UNITED STATES PATENT AND TRADEMARK OFFICE

APPLICATION NO.	FILING DATE	FIRST NAMED INVENTOR	ATTORNEY DOCKET NO.	CONFIRMATION NO.
10/588,775	08/08/2006	Yasuhiro Okamoto	Q96219	9772
23373	7590	04/15/2009	EXAMINER	
SUGHRUE MION, PLLC			LI, MEIYA	
2100 PENNSYLVANIA AVENUE, N.W.			ART UNIT	PAPER NUMBER
SUITE 800			2811	
WASHINGTON, DC 20037				
		MAIL DATE	DELIVERY MODE	
		04/15/2009	PAPER

Office Action Summary	Application No. 10/588,775	Applicant(s) OKAMOTO ET AL.
	Examiner MEIYALI	Art Unit 2811

DETAILED ACTION

Fig. 1A

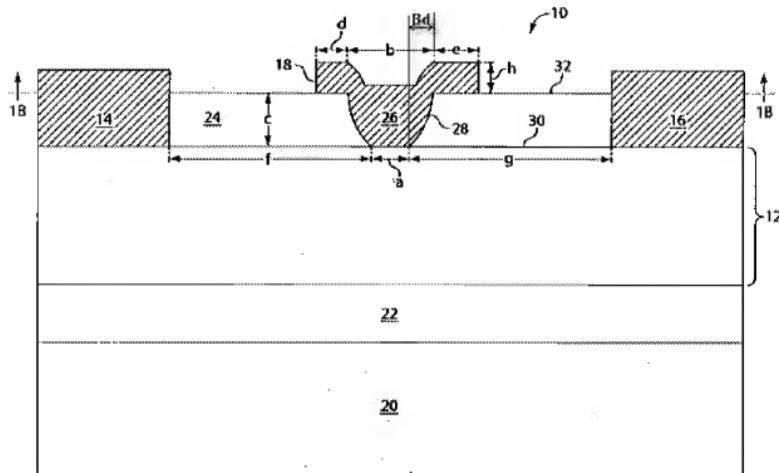
As for claims 1 and 4, Johnson et al. show in Fig. 1A and related text a field effect transistor 10 comprising:

a III group nitride semiconductor layer structure including hetero junction 22/12 ([0064]-[0070]);

a source electrode 14 and a drain electrode 16 that are so formed on said semiconductor layer structure 8 as to be separated from each other,

a gate electrode 18 formed on said semiconductor layer and between said source electrode and said drain electrode; and

an insulating film 24 formed on said semiconductor layer structure,
wherein said gate electrode has a field plate portion (Bd+e) that projects towards
said drain electrode in the form of an eave and that is formed on said insulating film;
wherein a thickness of a portion of said insulating film lying between said field
plate portion and said semiconductor layer structure gradually increases from said gate
electrode toward said drain electrode, and
wherein said thickness of said portion of said insulating film varies continuously.

As for claim 11, Johnson et al. show a thickness of said field plate portion gradually decreases from said gate electrode toward said drain electrode.
